Rez A-A:  
70mm  
min. 50mm  
40mm  
40mm

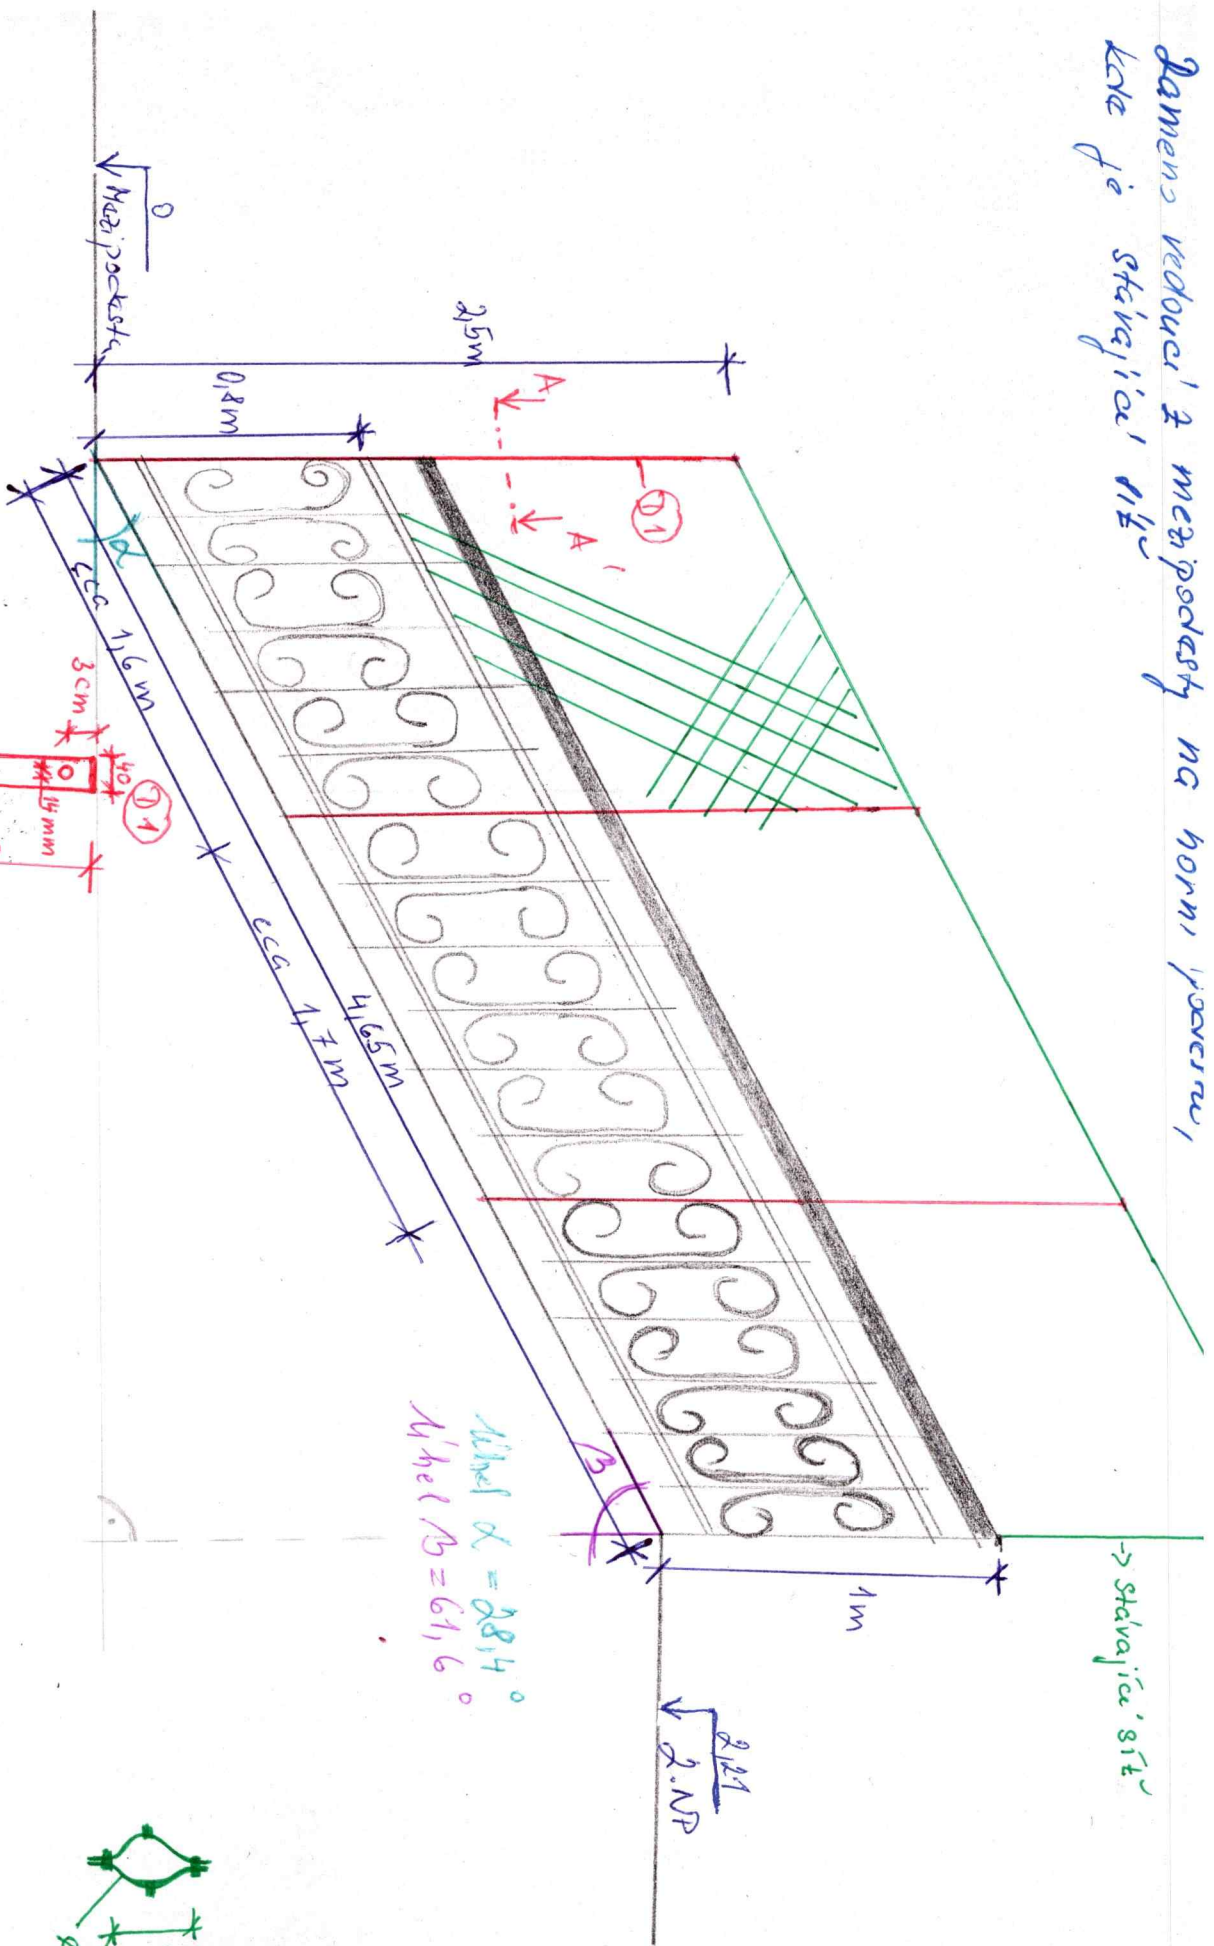
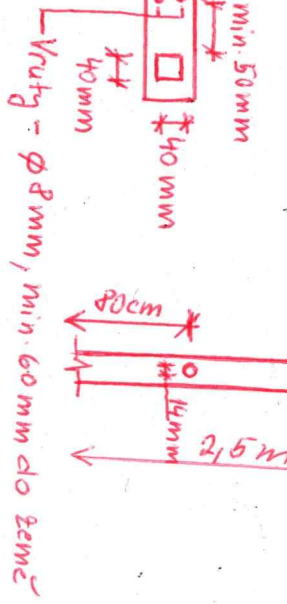
zamena veducej a mezpodesty na horni posuvnu,  
kde je stavajica' stiz'

⇒ 3x dvojpaek 40x40 mm

uhel  $\alpha = 28,4^\circ$   
uhel  $\beta = 61,6^\circ$

sta stenz  
skopka - 3mm

→ stava'ica' stiz'
